**TRUCK UTILITY LIGHTWEIGHT MC2 – LANDROVER SERIES 3 (ALL TYPES)  
CHASSIS TRANSMISSION CROSSMEMBER  
MODIFICATION INSTRUCTION**

### Introduction

FIG 1 - METHOD OF FIXING PLATES

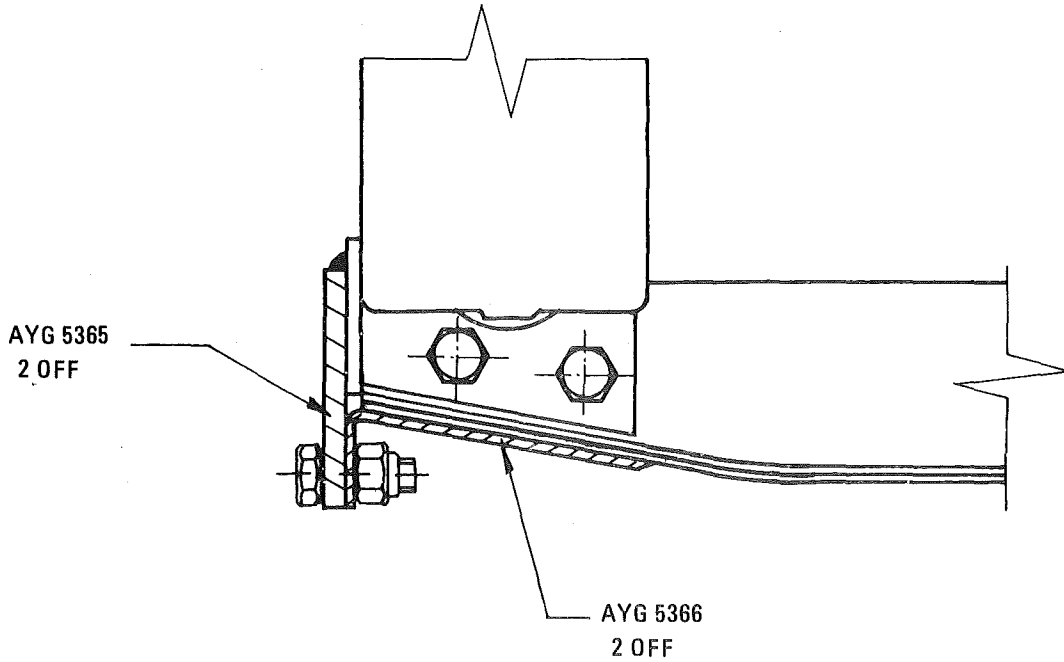
1. Any auxiliary fuel tanks fitted under the passengers seat are also to be removed.
- j. Ensure that the vehicle and immediate surroundings are free of fuel residue/vapours before proceeding.
- k. Remove the four (4) nylock nuts from the transmission crossmember attachment bolts, to prevent damage during the welding operation.
- l. Using slave bolts and nuts instead of bolts, item 4 from Table 1, and nuts, item 5, join plates, items 2 and 3 as shown in Fig 1.

1. Slave bolts and nuts must be used during the welding operation to prevent damage to the lock nuts.

FIG 2 - METHOD OF WELDING TO CHASSIS PLATE

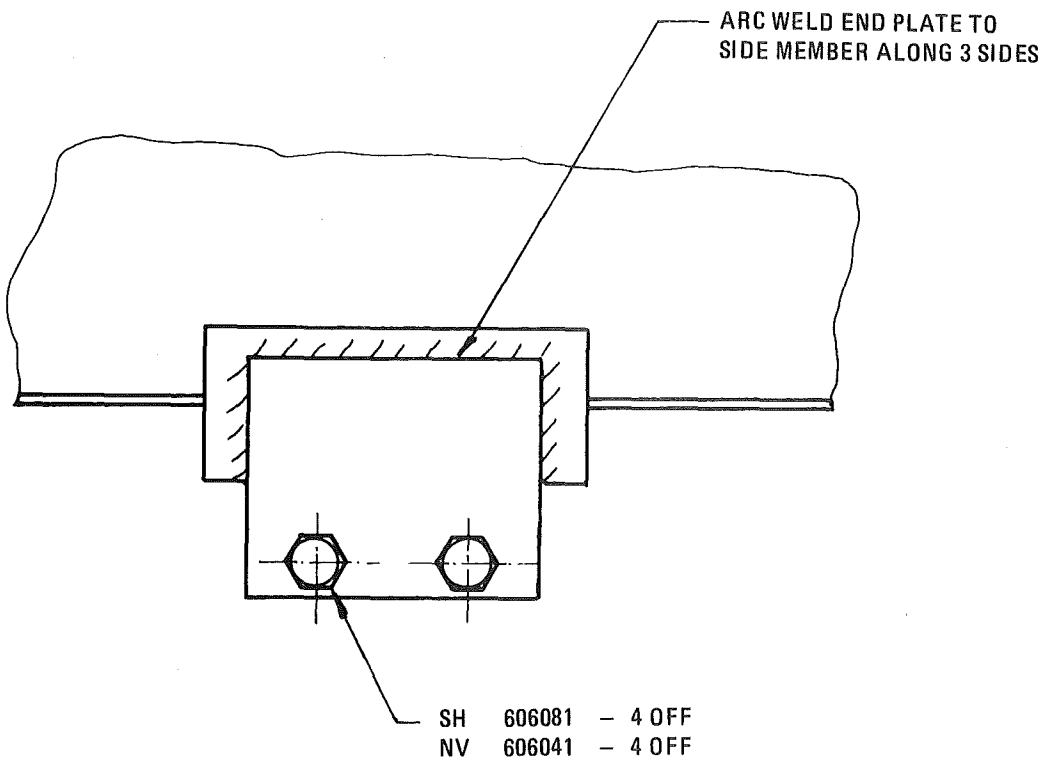
- o. Using a suitable welding technique and a 3.25 mm mild steel rod, affix the modification plates to the chassis plate and crossmember as shown in Figs 2 and 3.
- p. Clean the weld affected areas and paint in accordance with WKSP B 700.
- q. Replace and tighten the four(4) nylock nuts on the crossmember attachment bolts.
- q. Replace and tighten the four (4) nylock nuts on the crossmember attachment bolts.
- r. Remove the slave nuts and bolts from the modification plates and fit the four (4) bolts and nuts, items 4 and 5 from Table 1.
- s. Replace all components in reverse order to that given in sub-paragraphs 9 a to 9i.

### FIG 3 – METHOD OF WELDING TO CROSSMEMBER

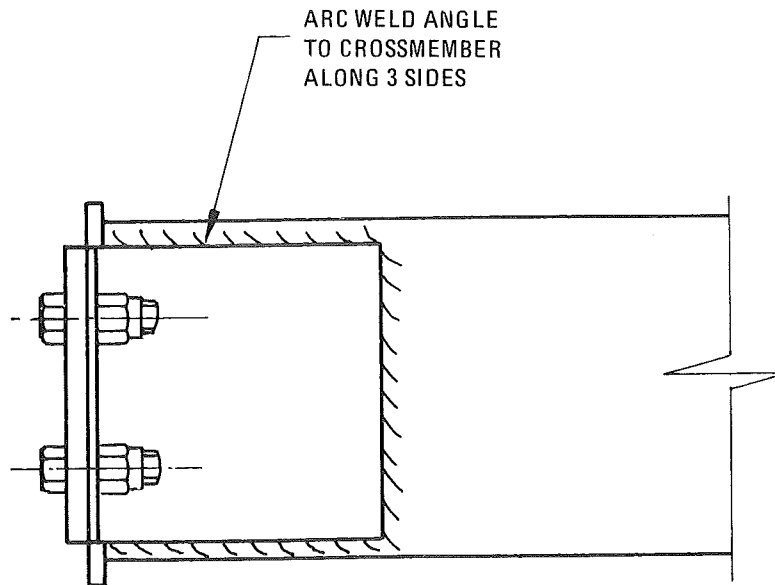
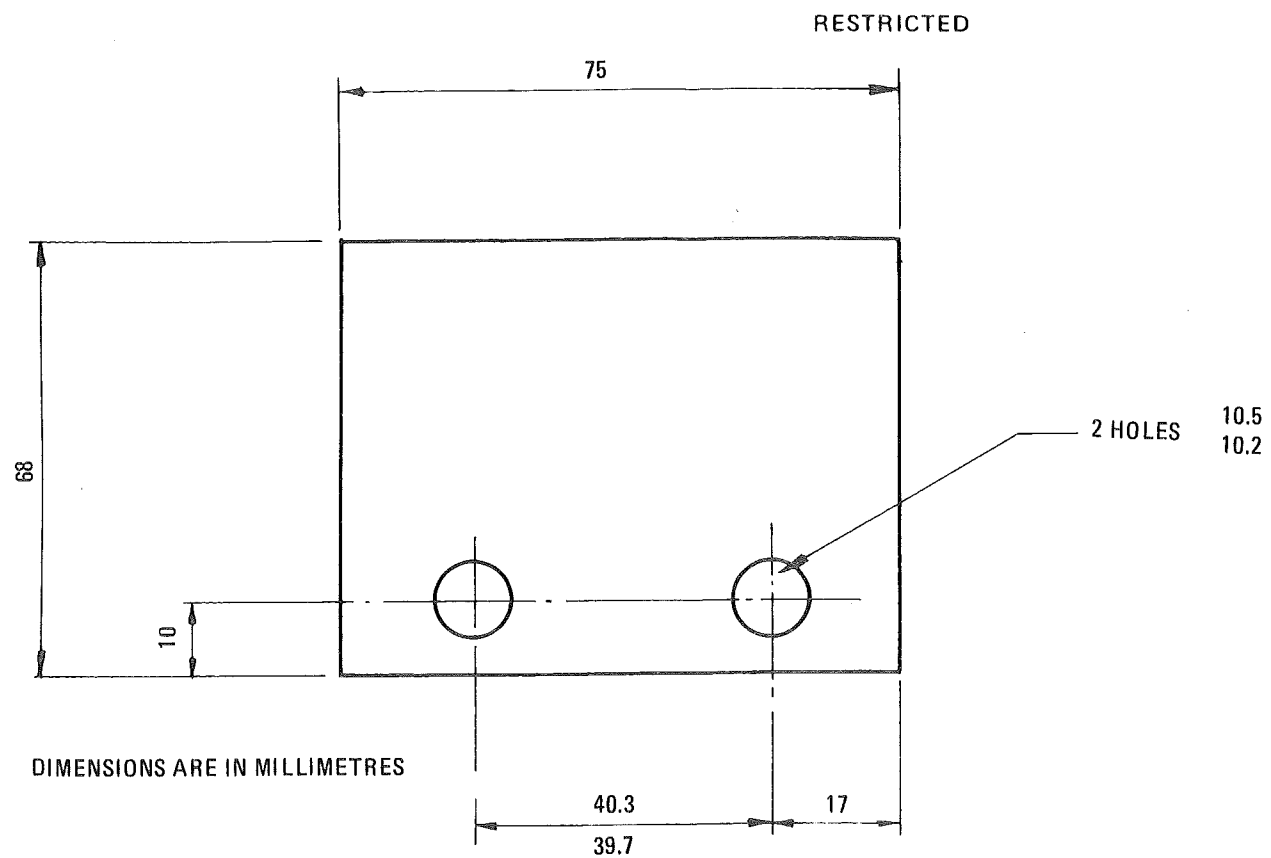
BOTH ENDS OF CROSSMEMBER  
TO BE MODIFIED THUS

FIG 4 - REINFORCING PLATE MANUFACTURING DETAILS  
E N D

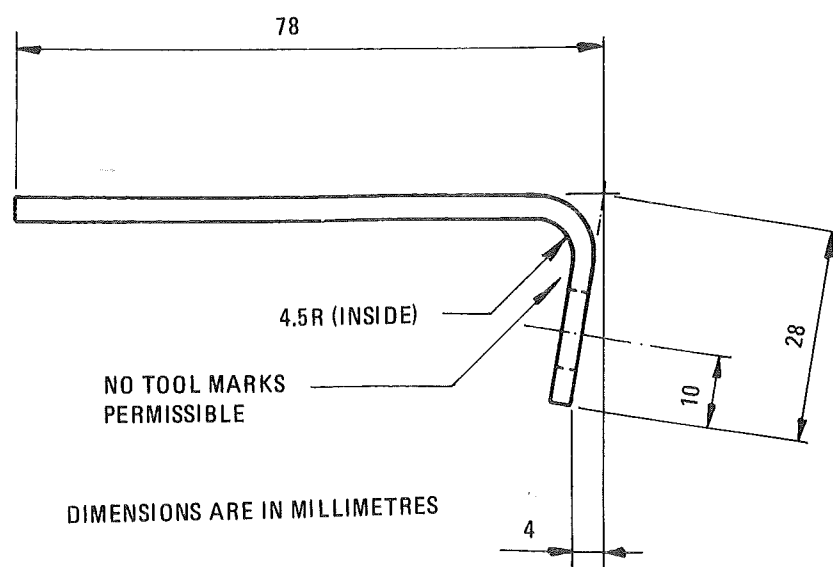
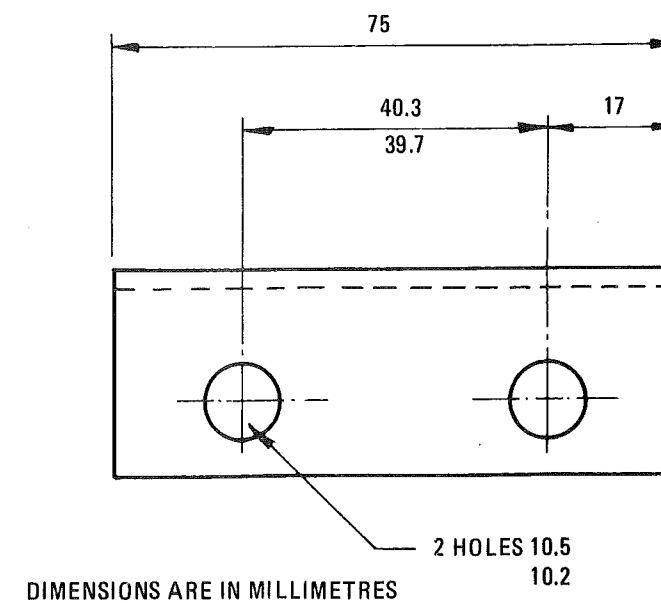
- 11. In the event that similar modifications are required in the future, modification plate manufacturing details are shown in Fig 4.

AYG 5365 N.S.D END PLATE  
MATERIAL - 6 THICK MILD STEEL

AYG 5366 NSD ANGLE  
MATERIAL 3.0 CRC
